Planning Board – Monday, July 27, 2020, 6:30PM

SPR-972 MODIFICATION #6 – SITE PLAN REVIEW – COLONY MILL RETAIL BUILDING, 210-222 WEST STREET

Re: Response to Comments on Site Plan Application SPR-972
Colony Mill Commercial Building – 222 West Street
Keene, New Hampshire

Figure 5. An excerpt of Sheet CS1-02, Site Layout Plan of the application, which shows the flow of vehicles into and out of the proposed drive-through lanes on the site.

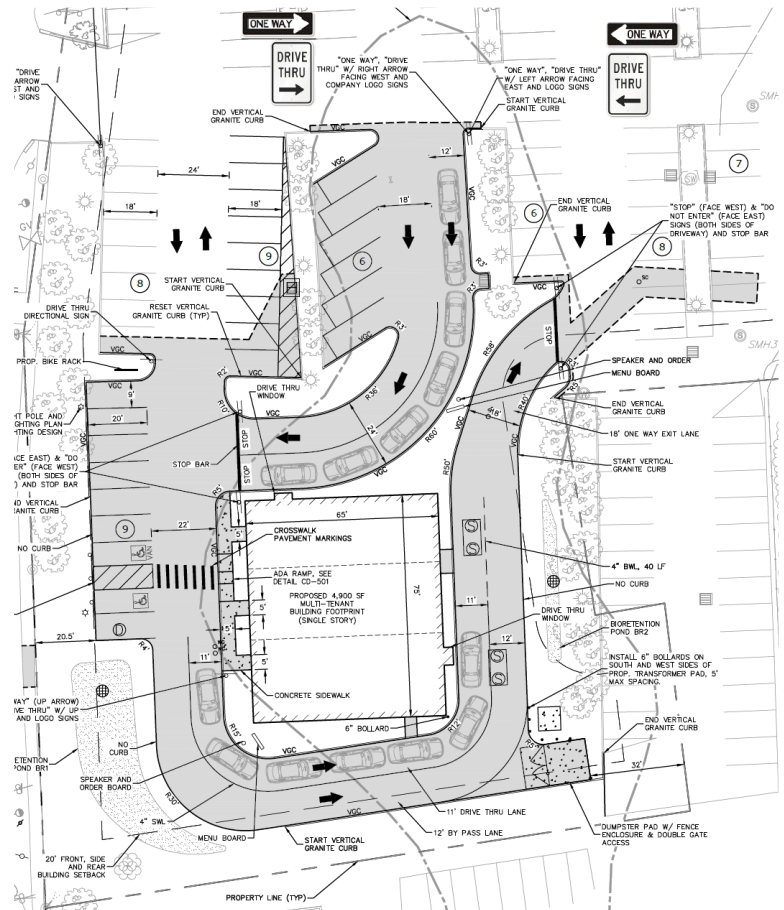
As noted earlier in this Staff Report, the proposal includes the installation of two drive-through lanes - one at the north of the proposed building, and the other on the south side of the same building. Sheet CS-102 of the plan set shows the proposed flow of vehicles into and out of these drive-through lanes. An excerpt of this plan sheet is shown in Figure 5 to the right. Staff have addressed concern with the applicant for the potential vehicular conflicts posed by queuing of the proposed drive-throughs, as the entrance for the southern-most drive-through is shared with the exit for the northern-most drive-through. There is also concern for the potential conflict that queued vehicles in the drive-through lanes would cause with parked vehicles in the adjacent parking areas. If the queue lengths of these drive-through lanes exceed the space allocated on the plan, queued vehicles in the southern-most drive-through may block vehicles from exiting the northern-most drive-through, and would impede the ability of vehicles parked in front of the proposed building (adjacent to Island Street) from backing out. Similarly, if more than 7 cars are queued in the northern-most drive-through, vehicles will be queuing in the main travel aisle to access the entrance/exit to the southern portion of the site. The Planning Board may consider asking the Applicant how these potential vehicular conflicts would be prevented / mitigated.

CG-101

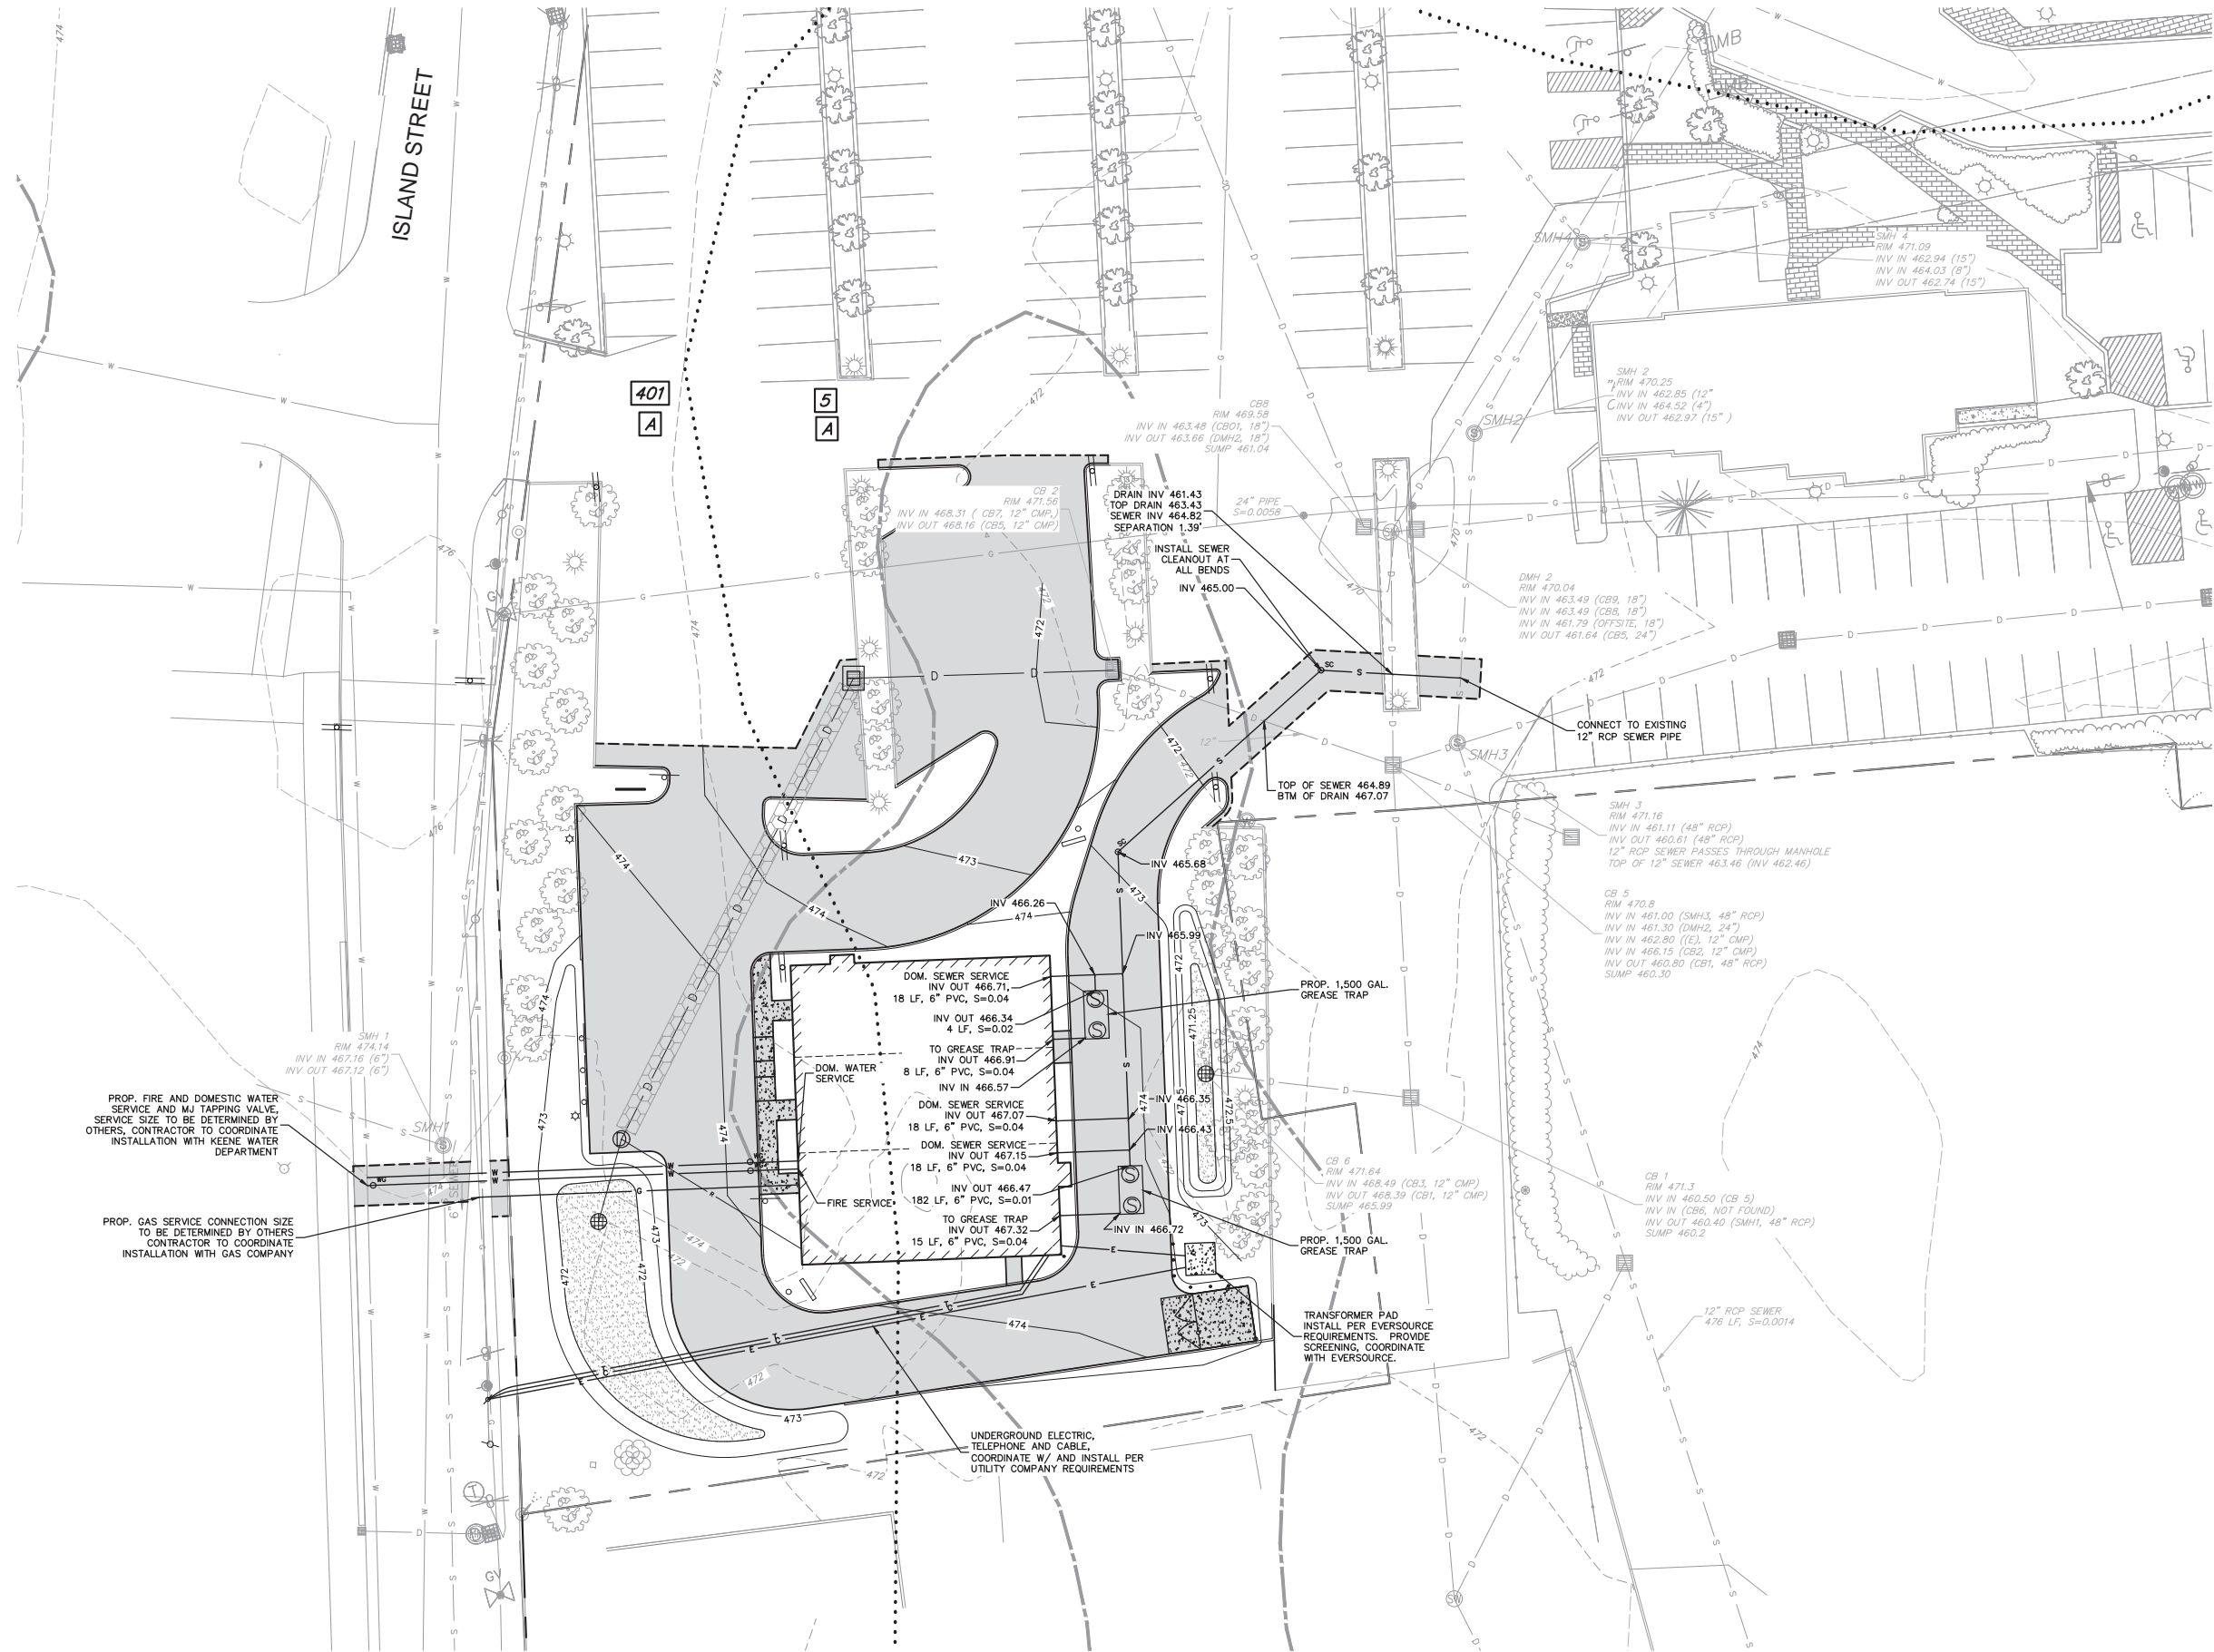
17. Please provide high-point spot grades as needed to clarify the intent of the grading at proposed parking areas (Sheet #CG-101). Additional spot grades added along with slope arrows.

20. The proposed 15” perforated storm drain pipe length is labeled 110-feet on Sheet #CG-101, but it is 125-feet long in the drainage report. Please revise/edit the site plan to reflect what is shown in the drainage report, or vice versa. Plan corrected to 125 lf.

CL-101

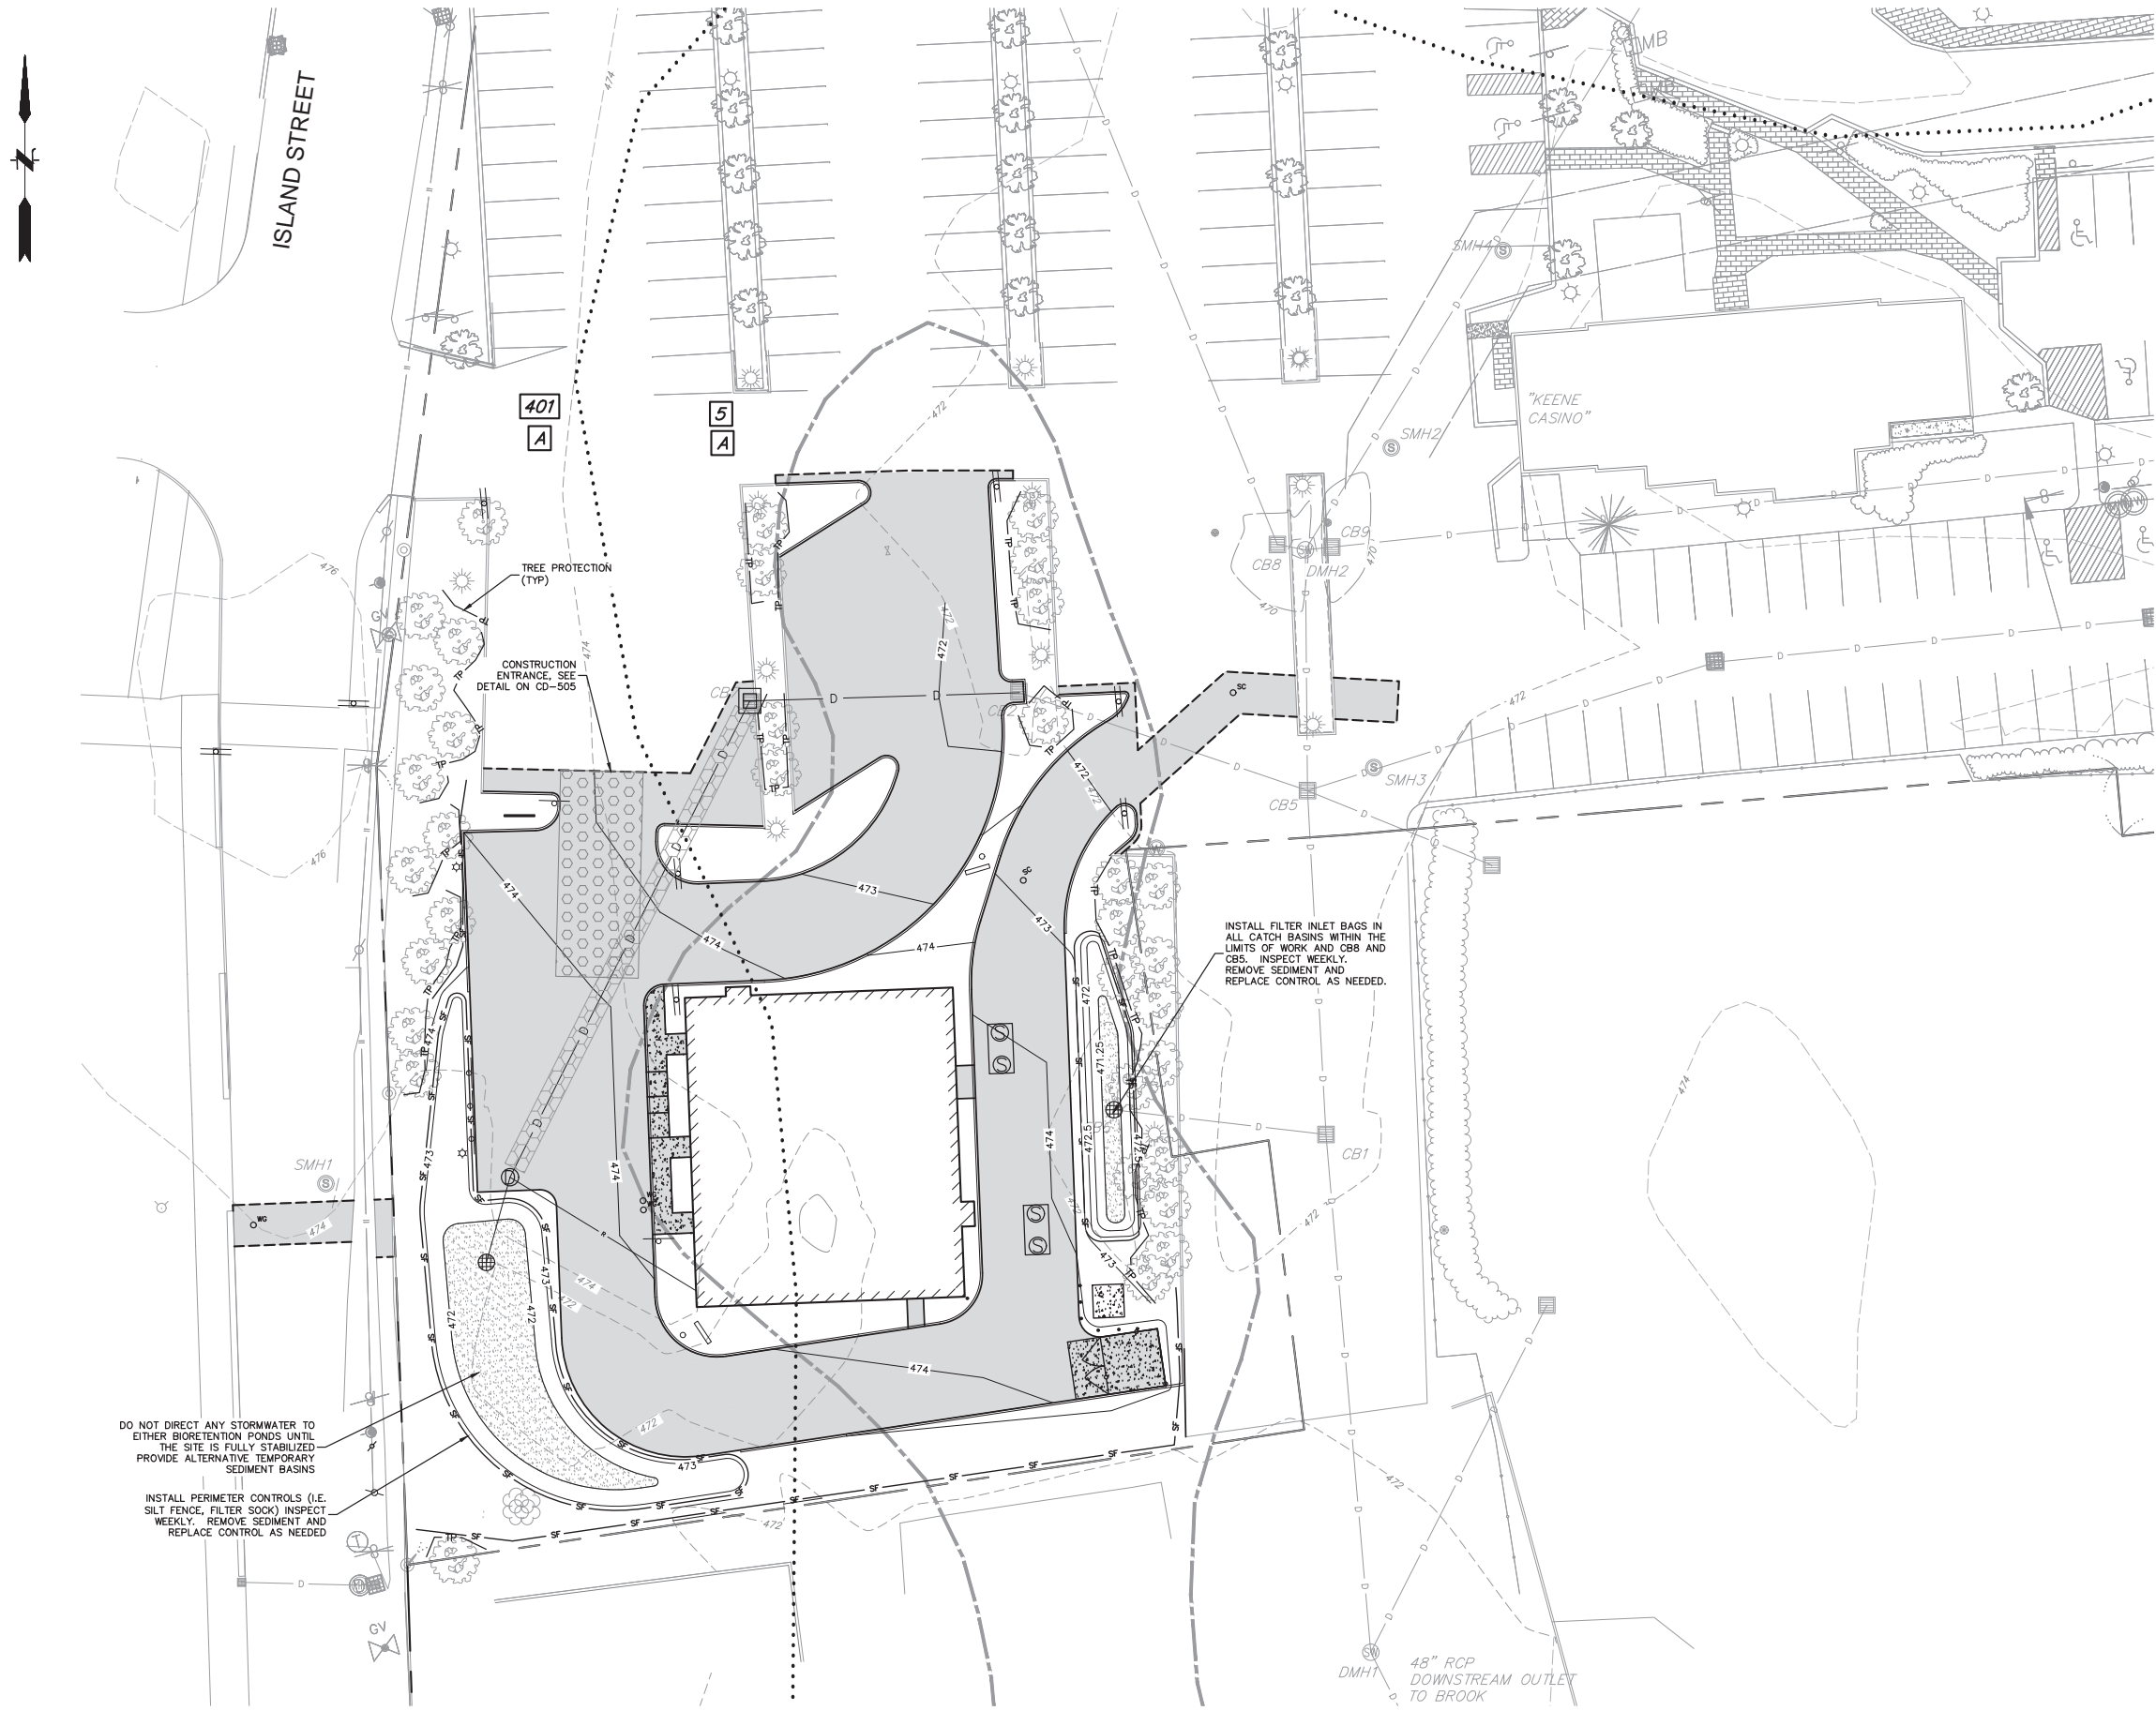
According to the Lighting Plan submitted by the Applicant, light levels would cross the southern property boundary onto the parcel at 70 Island Street (0.1 fc) as well as onto the public right-of-way for Island Street (0.8 fc). The Applicant has submitted a waiver request from this standard to allow light levels to cross the southern property boundary onto the adjacent parcel at 70 Island Street and to allow light levels in excess of 0.2 fc to cross the western property boundary onto the Island Street right of way. In determining whether to grant this waiver request, the Board should consider the Planning Board's waiver criteria, which are listed below.
